Rezoning Transportation Analysis

Petition Number: 2019-156

General Location Identifier: 08114708, 08114709

| Date | Description |
|------------|--------------------|
| 12-19-2019 | First Review |

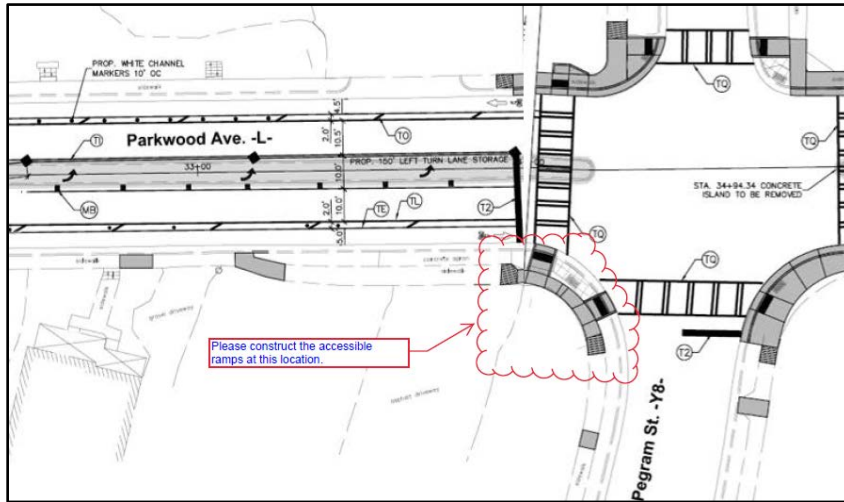
- ~~**Curblines** The proposed zoning district has a setback measured from back of the existing or proposed future curblines.~~

- ~~**Parkwood Avenue:** The future location of curb and gutter is in its existing location.~~
 - ~~**Pegram Street:** The future location of curb and gutter is in its existing location.~~

~~The site plan should show the curb and gutter labeled and dimensioned from the centerline for each road.~~
- ~~**Traffic Study** A Traffic Impact Study is not necessary for the complete review of this petition.~~
- ~~The petitioner should revise the site plan and conditional note(s) to commit to construct two directional ramps at the intersection of Parkwood Avenue and Pegram Street, per the *Parkwood (N. Davidson – The Plaza) Improvements* construction plans. Please refer to these plans within the rezoning site plan and conditional note(s). The *Parkwood (N. Davidson – The Plaza)* plans are available upon request.~~

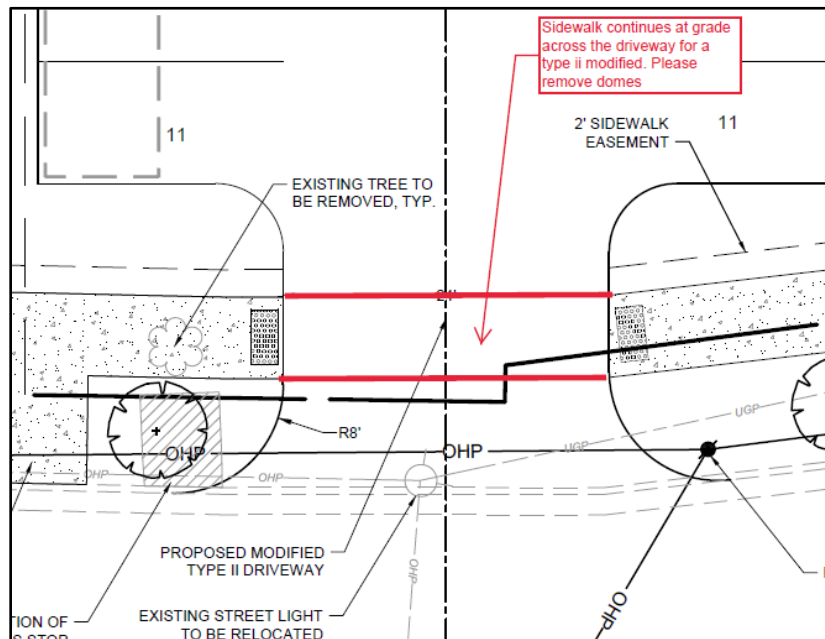
4. ~~The petitioner should revise the site plan and conditional note(s) to remove the truncated domes and to continue the sidewalk at grade across the driveway.~~

5. ~~The petitioner should revise the site plan to add a note specifying dedication and fee simple conveyance of all rights of way to the City before the site's first building certificate of occupancy is issued. CDOT requests right of way set at 2 feet behind the back of sidewalk where feasible.~~

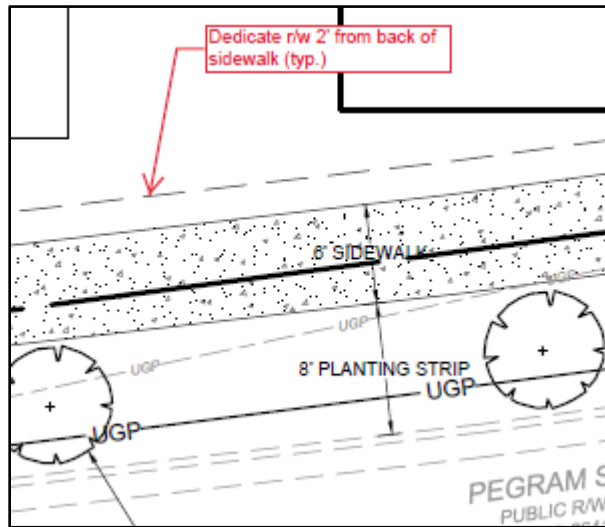
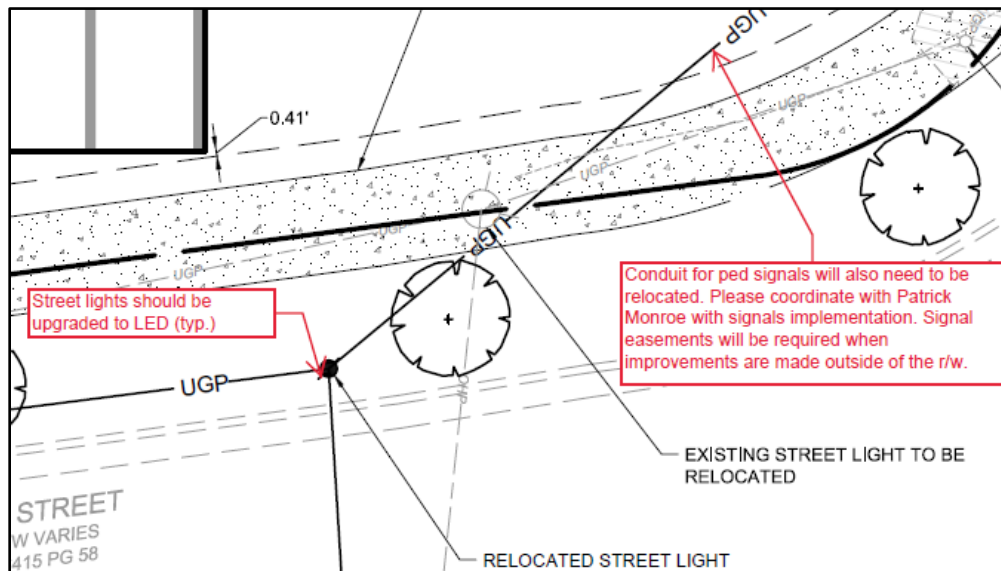
6. ~~The petitioner should revise the site plan and conditional note(s) to include utility easements where underground conduit is placed outside of the public r/w for the relocated street lights. The petitioner should commit to upgrading the street lighting along the site's right-of-way frontage to LED. Coordinate with Patrick Monroe (Patrick.Monroe@ci.charlotte.nc.us at 704-336-3937).~~
